CHANGE ORDER

Change Order No. **8**

Date of Issuance: 3-28-19	Effective Date:
Owner: Topsfield Water Department	Owner's Contract No.:
Contractor: Kinsmen Corporation	Contractor's Project No.:
Engineer: Wright-Pierce	Engineer's Project No.: 13257D
Project: Topsfield Water Treatment Plant – Contract 1	Contract Name:

Description: Contract Extension, Generator Gas Piping, Aeration Tower Automatic Drain

TOPSFIELD WATER DEPARTMENT
 TOPSFIELD, MASSACHUSETTS
 INSTRUMENTATION LOOP DIAGRAM #1

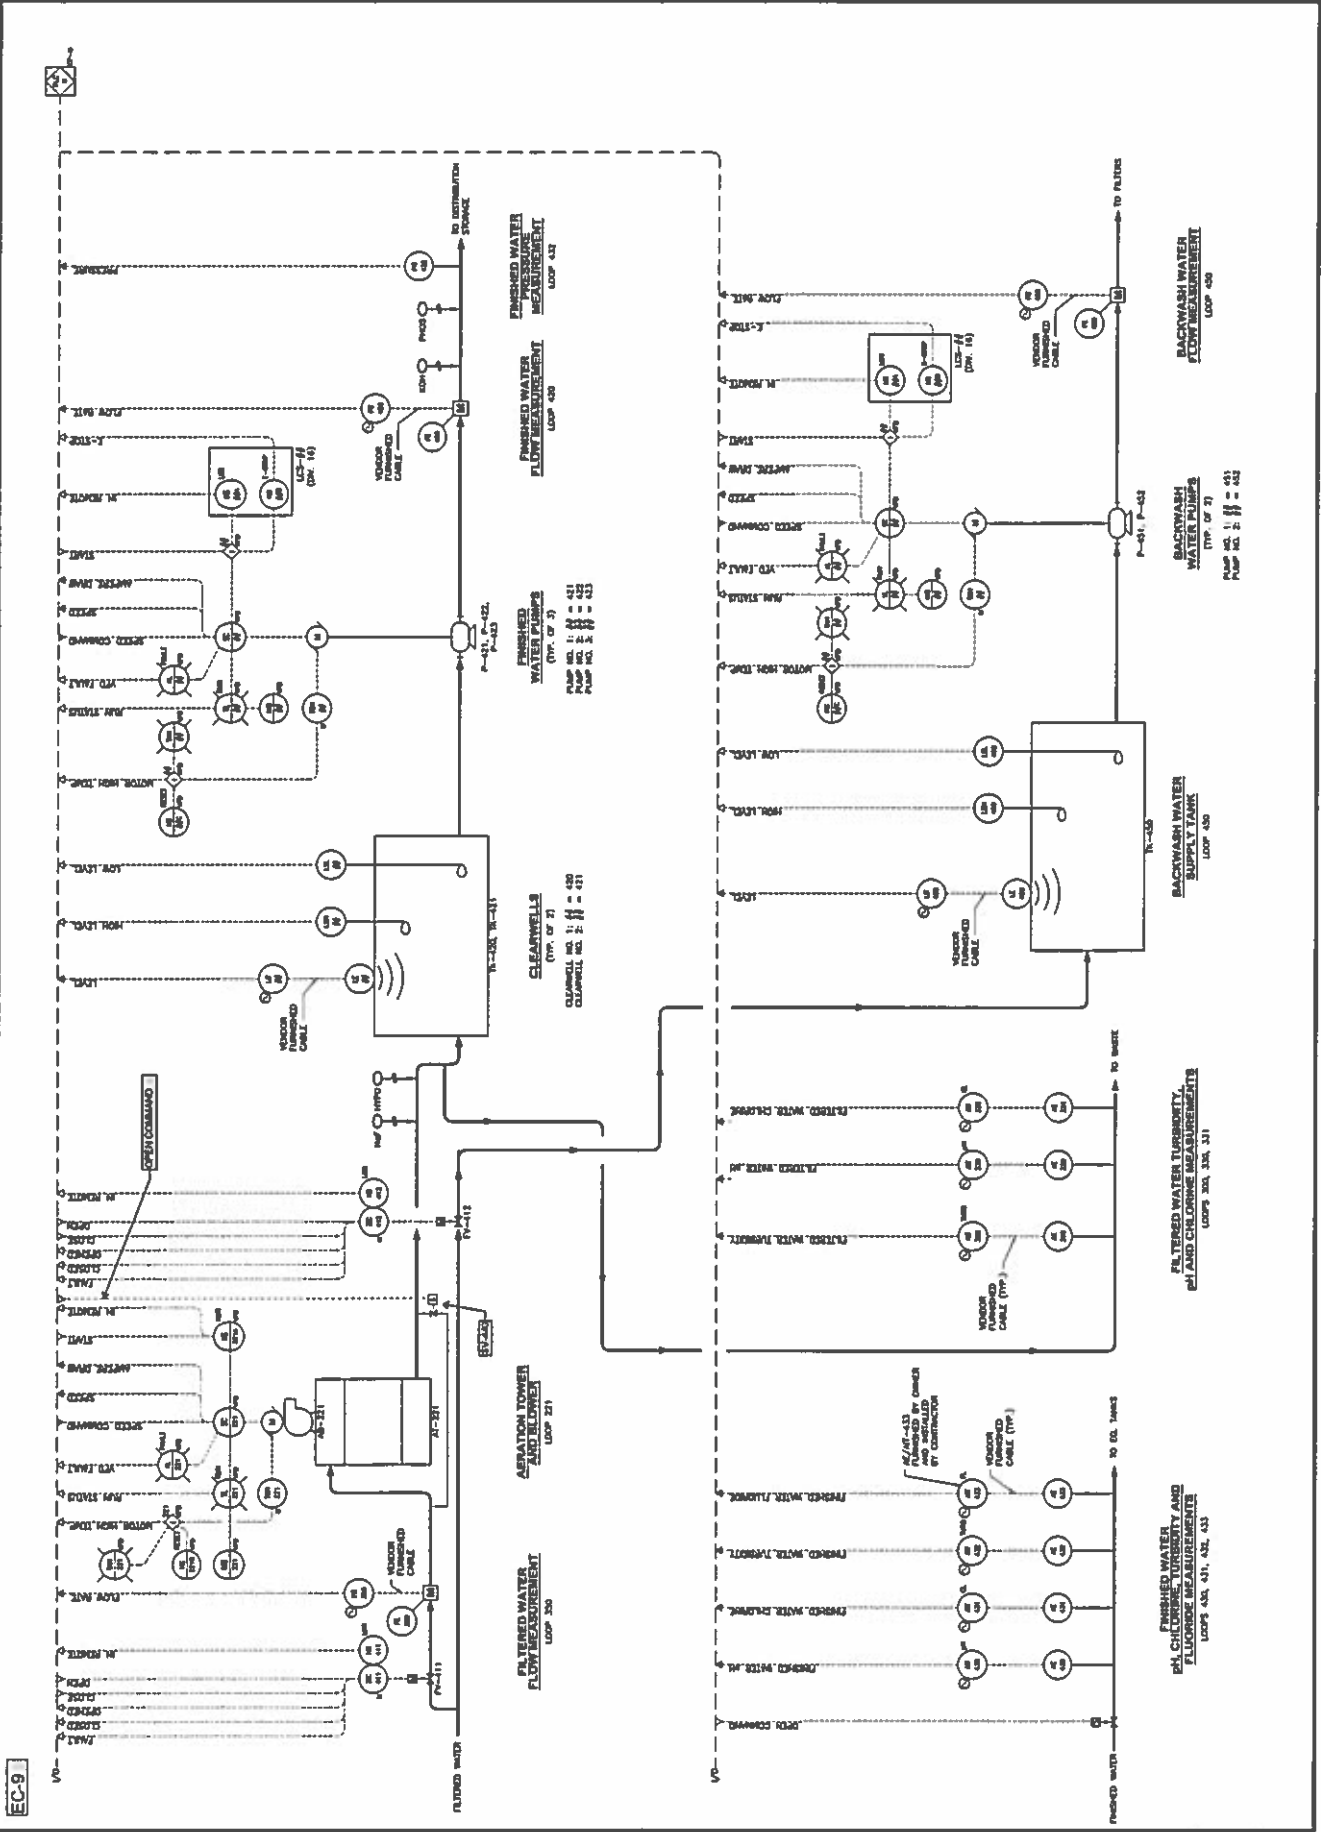
SUBJECT: Aeration Tower Drain

Please provide a cost (w/ back-up) to add an automated aeration tower drain line between the 8" DI aeration inlet and the 12" DI aeration tower outlet. This will allow Topsfield to automatically drain the exposed aeration tower inlet piping back into the clearwell to prevent freezing while the plant is offline in the winter.

The proposed solenoid valve (SV-440) shall be normally closed and energized to open via SCADA with an operator adjustable time set-point to allow the piping to drain. The solenoid shall be wired to a spare DI input in the Main Control Panel PLC and shall be incorporated into the plant shut-down sequence programming.

Please refer to the attached (3) sketches for additional details.
